ATTACHMENT 1 – KEY COMMENTS

REPORT NO: 1708/03.3

The submission to the Panel is in response to the invitation for submissions by the Panel and is intended to be considered as part of the Panel’s response to their second Term of Reference, viz:

Figure 3. Longwall 9 Investigation Site (source: Parsons Brinkerhoff (2015))

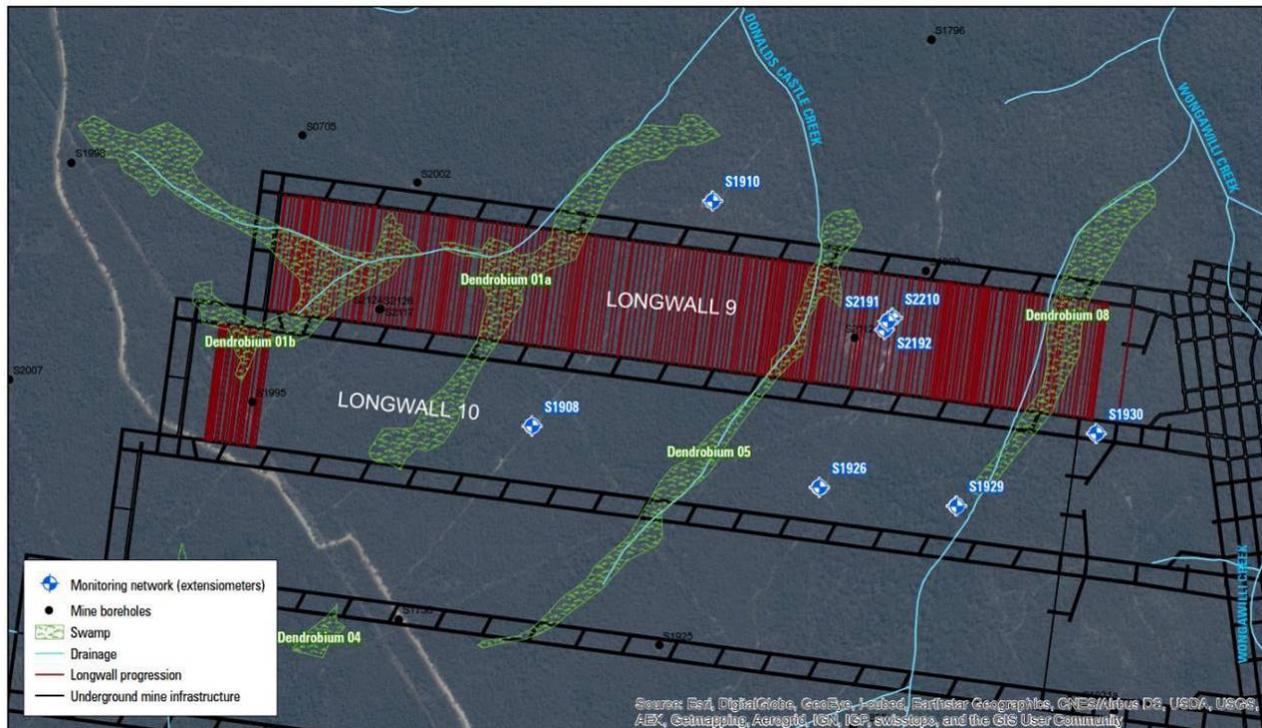
- On p17 of the report (and also discussed on p13), it is stated that none of the piezometer monitoring holes are in a suitable position over any Dendrobium Mine longwall panels to fully assess the hydrogeological response of the strata to mining. In fact, the detailed study

conducted by Parsons Brinkerhoff (2015) included a range of different monitoring systems (extensometers, piezometers, packer tests and tracer tests) conducted in boreholes above and adjacent to Longwall 9. Figure 3 shows the grouping of boreholes which included a group located directly over the centreline of Longwall 9, as well as some holes away from the panel edges. The centreline studies included both pre-mining and post-mining holes and monitoring investigations.
